TOMBALL INDEPENDENT SCHOOL DISTRICT
RFP #1000-26 Issued: May 18th, 2026
REQUEST FOR COMPETITIVE SEALED PROPOSALS
FOR THE CONSTRUCTION OF A NEW
HVAC System at the Lakewood & Willow Creek ES's

Addendum No. 02

Addendum 02

260018.003 | Tomball ISD - Chiller Package 1 - South (Lakewood ES (1d) & Willow Creek ES (1e))

TBPE Firm Registration No. 2234
DATE: 05/08/2026
DRAWN BY: DBR
CHECKED BY: DBR
PROJECT NUMBER 260018.003
SHEET TITLE: MECHANICAL PLAN - LAKEWOOD
SHEET NUMBER: LES-M2.12

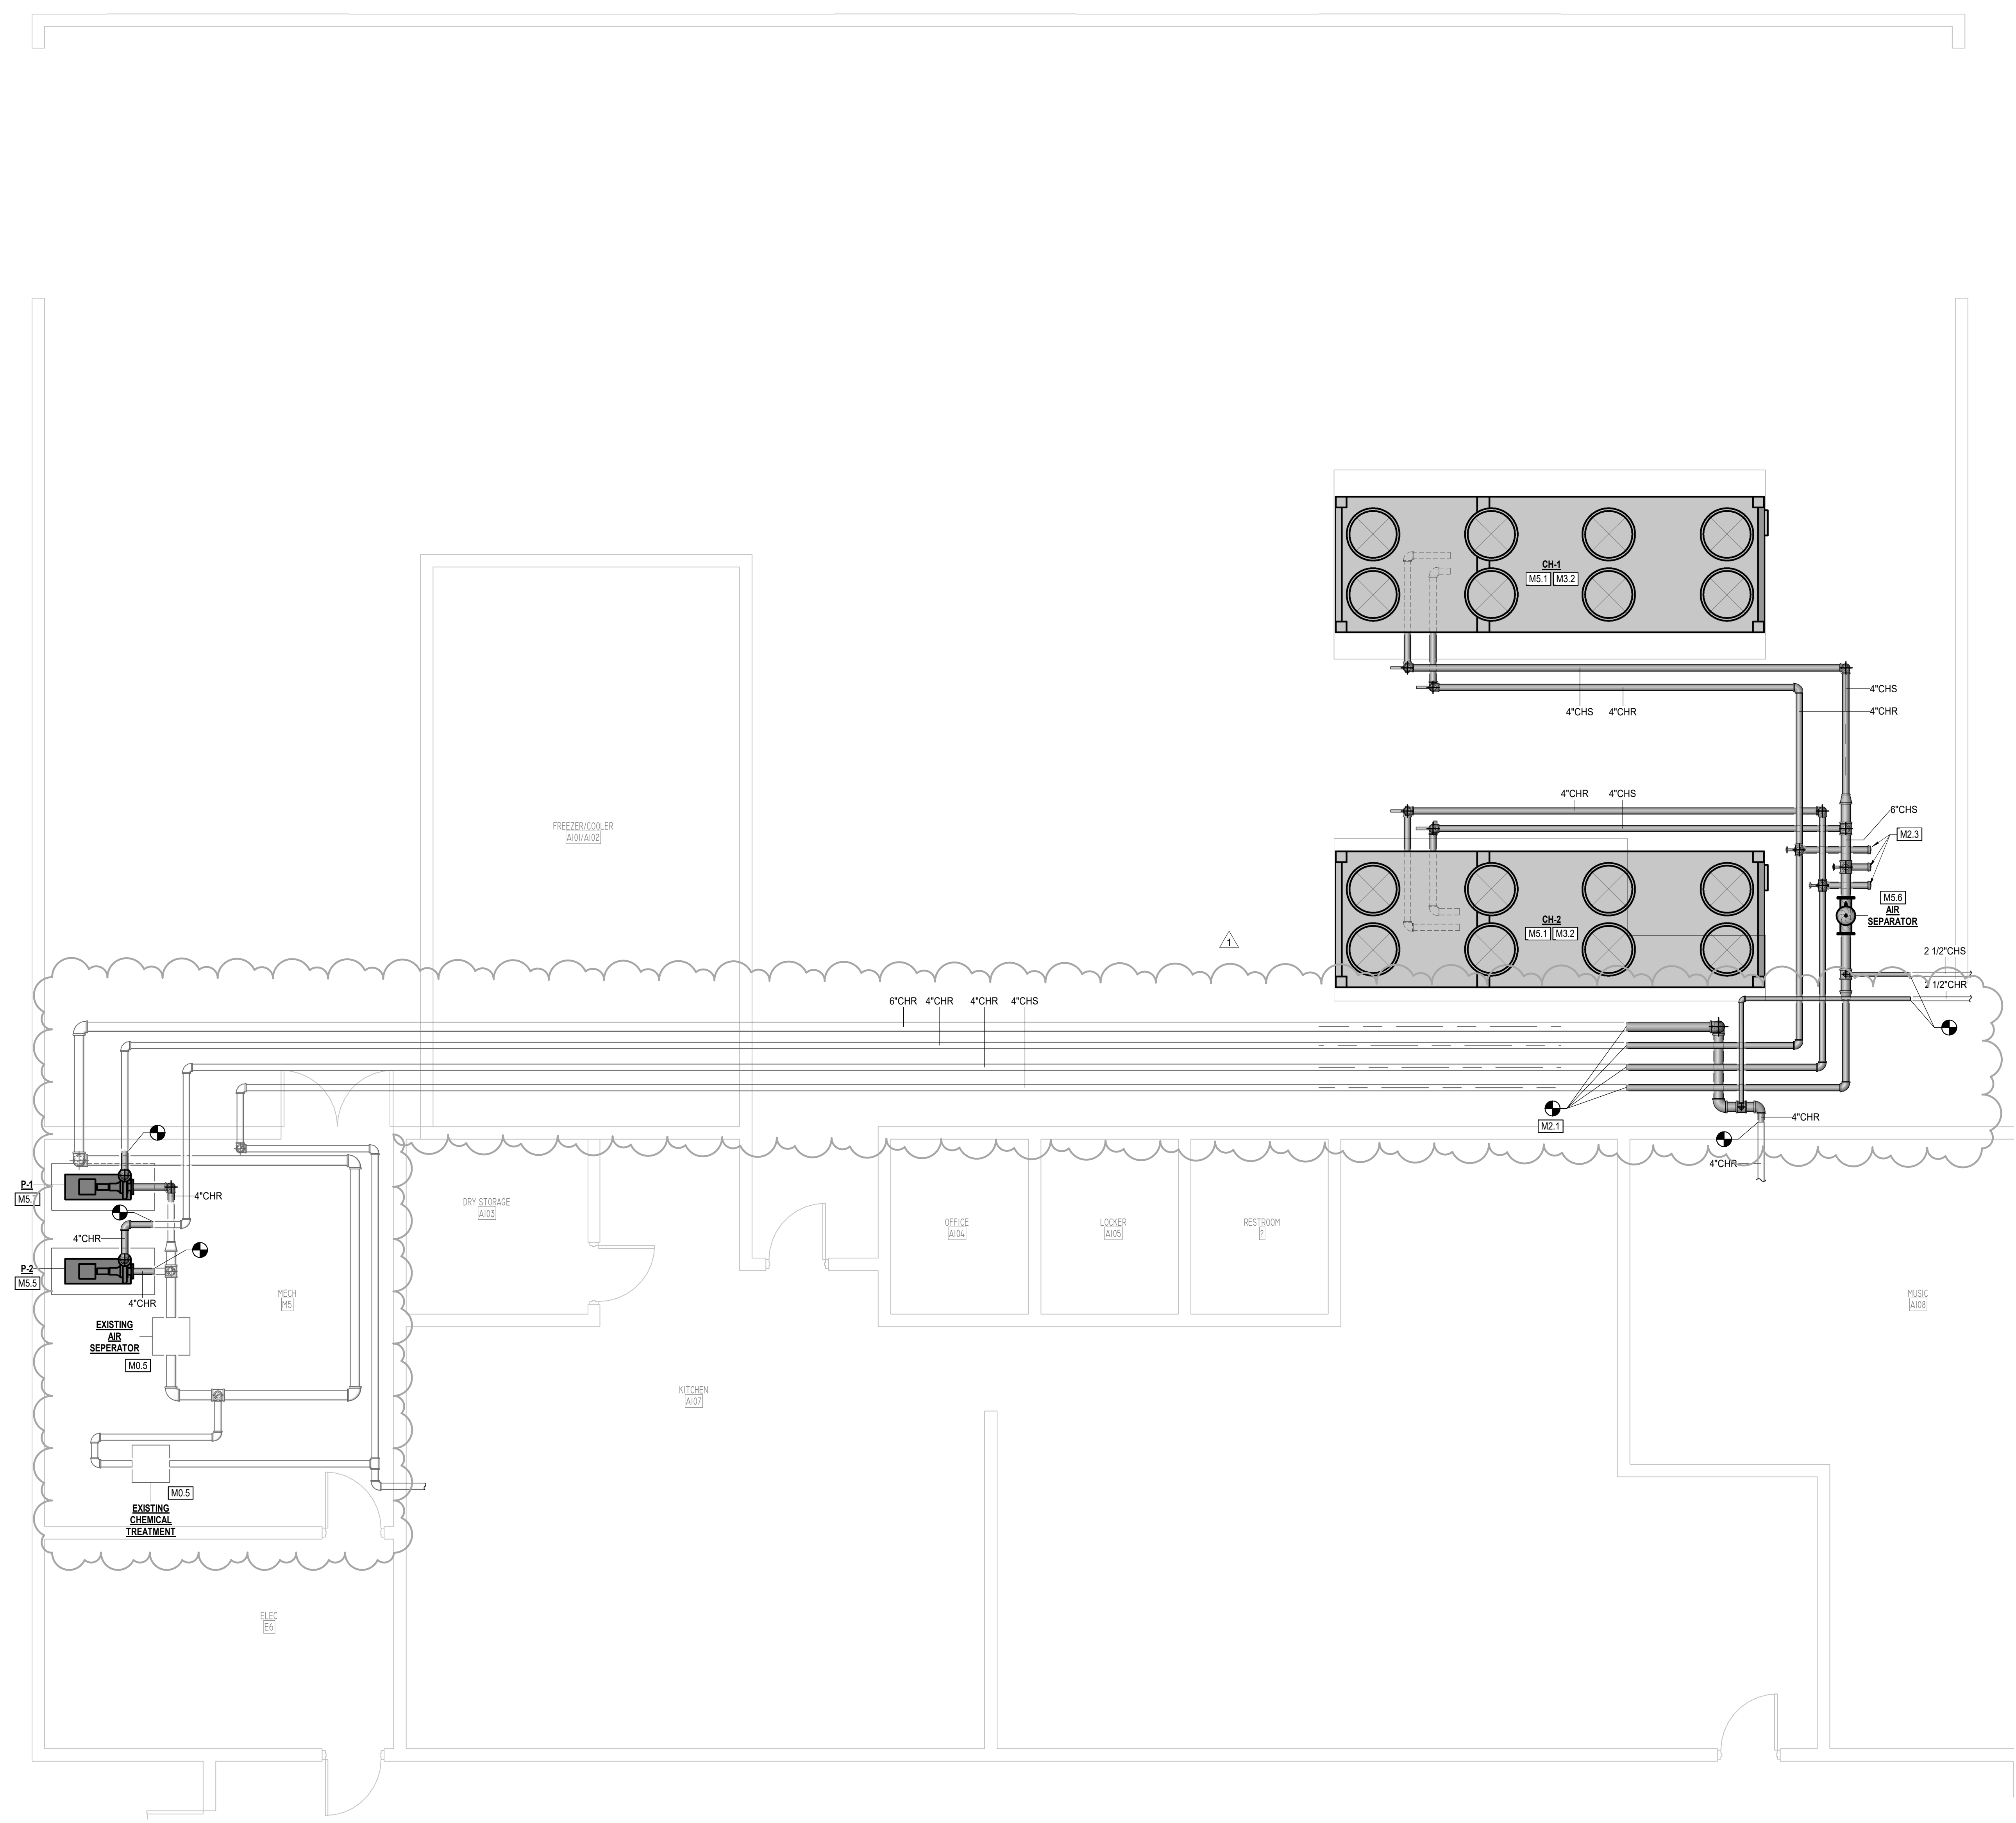
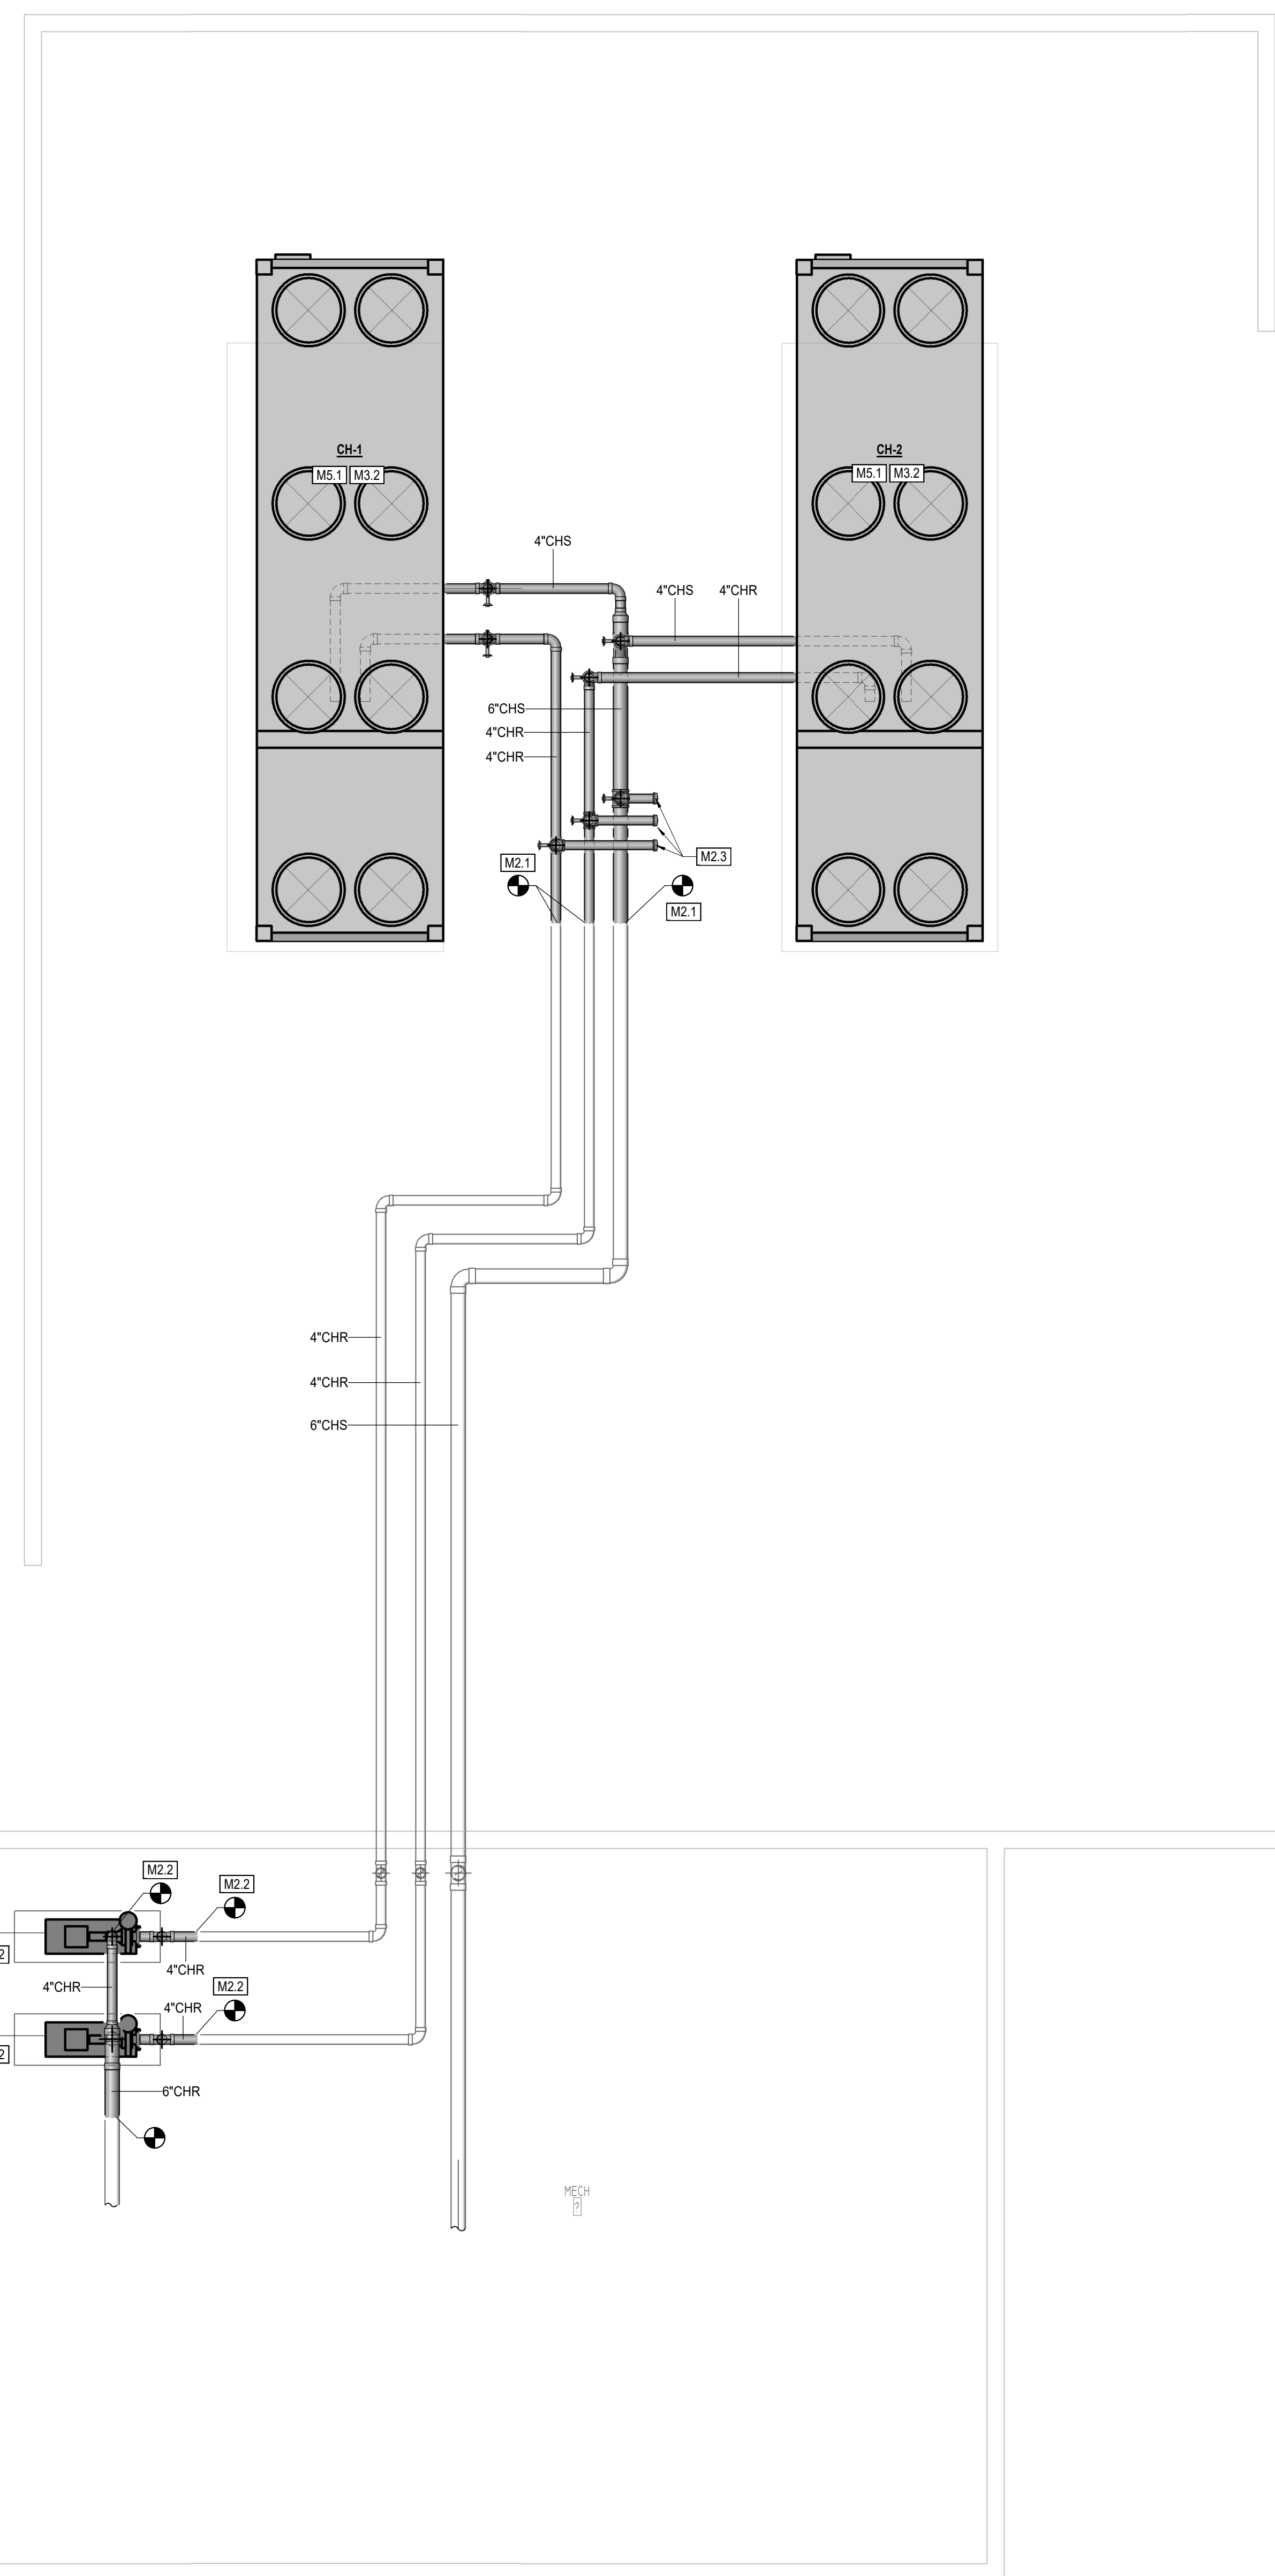
Item 02 **Sheet LES-M2.12 – MECHANICAL PLAN – LAKEWOOD**

- A. Revised keyed note M5.5 to clarify pump inertia base scope.
- B. Revised keyed note M5.7 to clarify pump inertia base scope.
- C. Revised existing hydronic piping main routing to more accurately reflect existing conditions.
- D. Removed demo/replacement scope of work for approximately 70' of 6" CHR hydronic main

- M5.5 PROVIDE END SUCTION PUMP, ASSOCIATED INERTIA BASE, AND ASSOCIATED ACCESSORIES AT APPROXIMATE LOCATION SHOWN. INSTALL PER MANUFACTURER'S WRITTEN INSTALLATION INSTRUCTIONS. INSTALL ON EXISTING CONCRETE HOUSEKEEPING PAD. EXTEND EXISTING PAD AS NECESSARY. RE: DETAIL 03M6.01.

- M5.6 PROVIDE AIR SEPARATOR WITH AUTOMATIC AIR VENT (BELL & GOSSET R-6F OR APPROVED EQUAL) AT APPROXIMATE LOCATION SHOWN AS PART OF ALTERNATE 4.
 - M5.7 PROVIDE END SUCTION PUMP, ASSOCIATED INERTIA BASE, AND ASSOCIATED ACCESSORIES AT APPROXIMATE LOCATION SHOWN AS PART OF ALTERNATE 4. INSTALL PER MANUFACTURER'S WRITTEN INSTALLATION INSTRUCTIONS. INSTALL ON EXISTING CONCRETE HOUSEKEEPING PAD. EXTEND EXISTING PAD AS NECESSARY. RE: DETAIL 03M6.01.

TBPE Firm Registration No. 2234
DATE: 05/08/2026
DRAWN BY: DBR
CHECKED BY: DBR
PROJECT NUMBER 260018.003
SHEET TITLE: MECHANICAL PLAN - WILLOW CREEK
SHEET NUMBER: WCES-M2.14

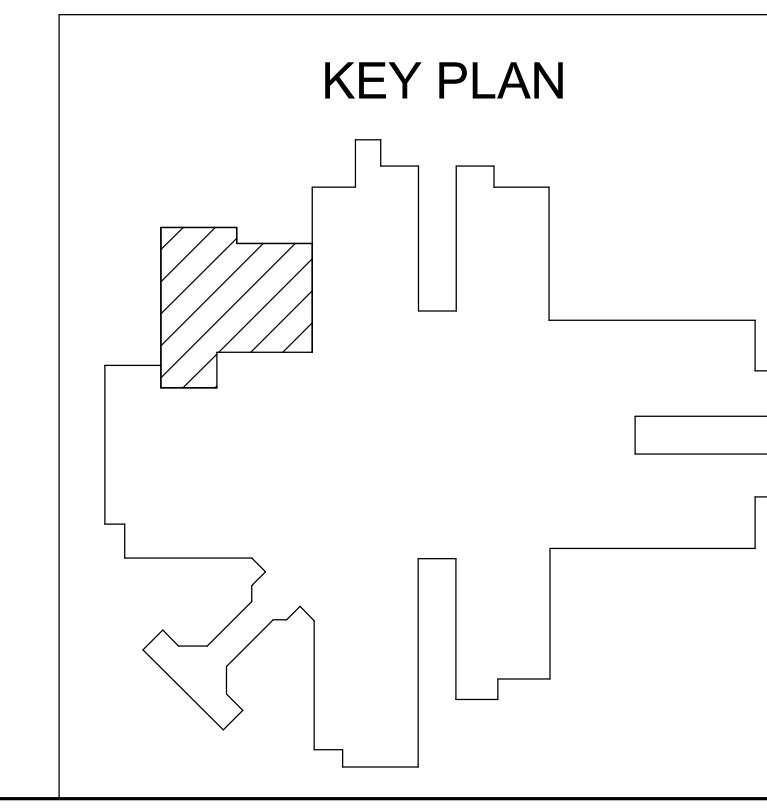
Item 03 **Sheet WCES-M2.12 – MECHANICAL PLAN – WILLOW CREEK**

- A. Revised keyed note M5.22 to clarify pump inertia base scope.

- M5.2 PROVIDE END SUCTION PUMP, ASSOCIATED INERTIA BASE, AND ASSOCIATED ACCESSORIES AT APPROXIMATE LOCATION SHOWN AS PART OF ALTERNATE B. INSTALL PER MANUFACTURER'S WRITTEN INSTALLATION INSTRUCTIONS. INSTALL ON EXISTING CONCRETE HOUSING PAD. EXTEND EXISTING PAD AS NECESSARY. RE: DETAIL G3/M5.01.
